Q: What are the stages of the proposed project? When and how does the Corps interface with the community at each stage?

The project is divided into two phases: The feasibility phase and the design and implementation phase (D&I). During the feasibility phase we study the problems, the opportunities, and constraints of the project and examine if it is feasible to construct. The next phase is the D&I where we design the project and execute the design. During both phases the public can comment and ask any questions that were not explained in the project report which was posted. There will be a period during D&I where the San Antonio River Authority will facilitate public participation. The public review period for this project during the feasibility phase is 60 days instead of the regular 30 days to maximize the public participation and to give more than enough time to address all comments and concerns. Comments and questions can be sent to email inbox at: RiverRoadER@usace.army.mil.

Bank Sculpting and Instream Structures

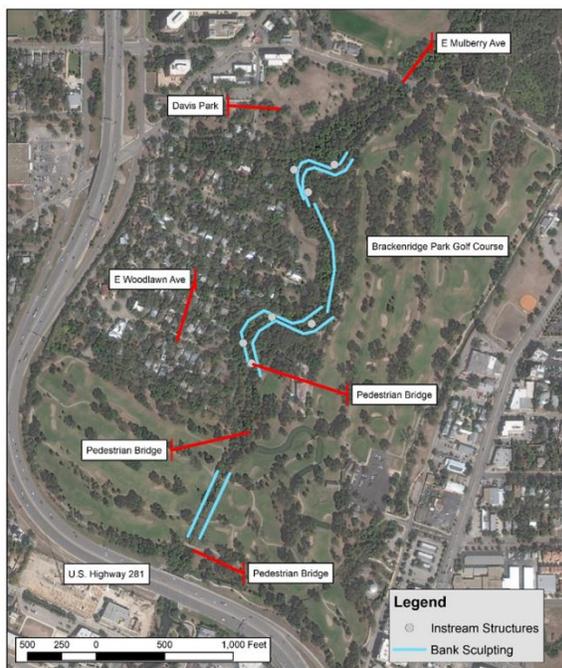
Q: Will bank sculpting call for removal of mature native trees (e.g. pecan, cedar elm?). If so, where?

There may be some native trees that will be impacted by bank sculpting; however, this will be avoided to the maximum extent possible and determined during the design phase. Our goal is not to remove native vegetation, only improve conditions for the existing native vegetation and promote more natural conditions for new native vegetation. The bank sculpting will be focused in those areas as shown on the figure below.
